Well Name: BIG EDDY Well Location: T21S / R29E / SEC 8 / County or Parish/State: EDDY /

Notice of Intent

PLUG AND ABANDON WELLBORE BIG EDDY UNIT 073 EDDY COUNTY, NEW MEXICO Class II

Permanent Abandonment of Federal Wells Conditions of Approval

BEU 073 - Proposed WBD

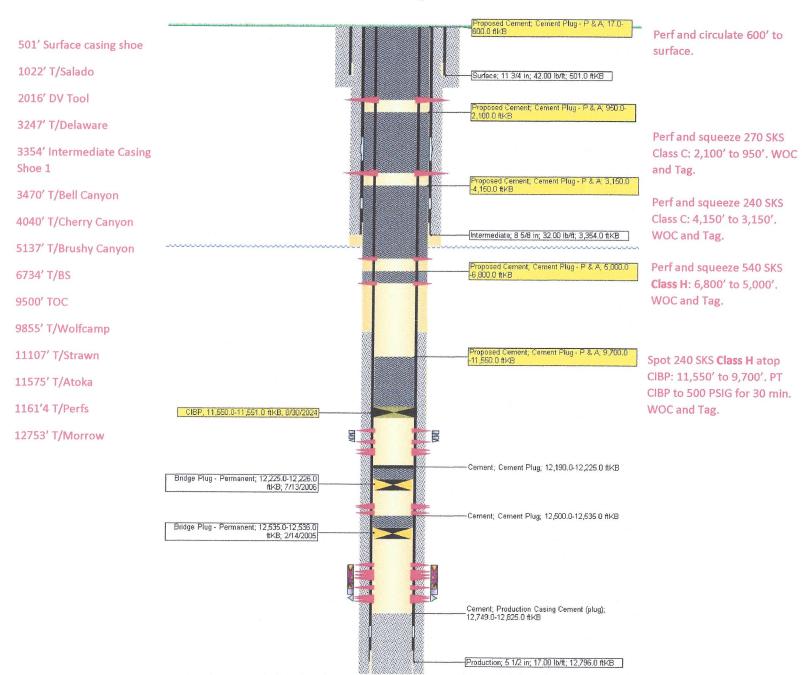
| Sundry ID | 2821771 | 1 | | ı | 1 | | 1 |
|--------------------------------|----------|----------|--------|---|--------|-----------------|--|
| Plug Type | Тор | Bottom | Longth | Tag | Sacks | Cement Class | Notes |
| DV tool plug | 1945.84 | 2066.00 | 120 16 | Tag/Verify | 269.00 | C | Perf and squeeze from 2100' to 950'. WOC and Tag. (In 114 sxs/Out 155 sxs) |
| 8.625 inch- Shoe Plug | 3270.46 | 4150.00 | 879.54 | Tag/Verify | 232.00 | С | Perf and squeeze from 4150' to 3150'. WOC and Tag. (In 99 sxs/Out 133 sxs) |
| Bonesprings @ 6697 | 6580.03 | 6800.00 | 219.97 | base no need to Tag (CIBP present and/or | 420.00 | С | Perf and squeeze from 6800' to 5000'. WOC and Tag. (In 178 sxs/Out 242 sxs) |
| CIBP Plug | 11515.00 | 11550.00 | | If solid base no need to Tag (CIBP present and/or Mechanic al Integrity Test), If Perf & Sqz then Tag, Leak Test all CIBP if no Open Perforations | 228.00 | Н | Set CIBP at 11550'. Leak test CIBP. Spot cement from 11550' to 9700'. WOC and Tag. |

No more than 2000' is to be allowed between plugs in open hole, and no more than 3000' between plugs in cased hole. Class H >7500' Class C<7500'

| Created By | | Condition Date |
|------------|---|-------------------|
| gcordero | Run CBL from 11550' to Surface | 1/30/2025 |
| gcordero | A Cement Bond Log (CBL) is required to be submitted to electronic permitting. | 1/30/2025 |
| gcordero | Submit Cement Bond Logs (CBL) prior to submittal of C-103P. | 1/30/2025 |
